STAFF REPORT: 9/14/2022 MEETING PREPARED BY: D. RIEDEN

APPLICATION NUMBER: #22-8010 **VIOLATION NUMBERS:** #624

ADDRESS: 4700 THIRD AVENUE

SCOPE: REPLACE PILASTERS AND ENTRANCE (WORK COMPLETED WITHOUT APPROVAL)

Sheet Title and Number ELEVATIONS

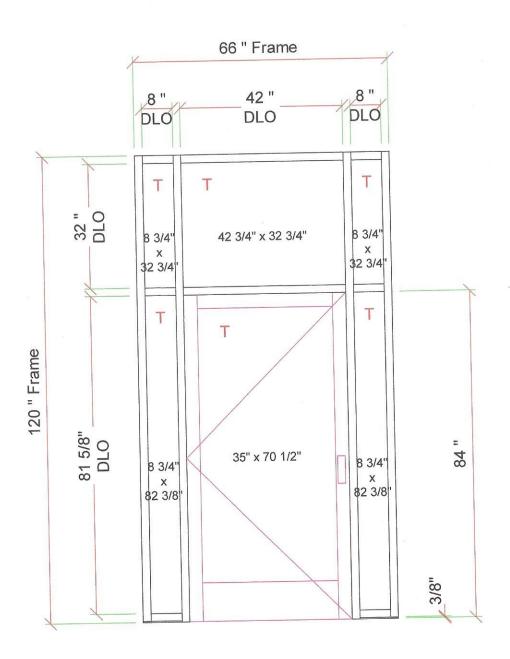
- Staff observed that the window on the south wall along Forest Ave is not placed in the position as proposed in the drawings in the following manner: both the window and the limestone sill are shown in the proposed drawing to match the running band of the walls. Currently the window and the limestone sill sit approximately 1' higher. It is staff's opinion that the proposed drawing would be appropriate over what was built without approval. (see Elevation 1, below and Site photo 1, above.)

- Staff identifies that the proposed window location in the drawings is an appropriate location, but the built location, without approval, appears to have been misplaced and interrupts the design and rhythm of limestone and brick interplay. Staff offers the opinion that the window on the south wall should be located as shown in the proposed drawing.

- The installed window and it's corresponding to limestone sill be reconstructed and placed according to the proposed drawings.
- The paint applied on the south wall be removed, or the applicant provide a paint scheme to HDC staff that addresses inconsistent application of paint on this wall.
- HDC staff shall review the final details of both the relocation of the window and limestone sill and the paint application for approval before the applicant executes these actions.
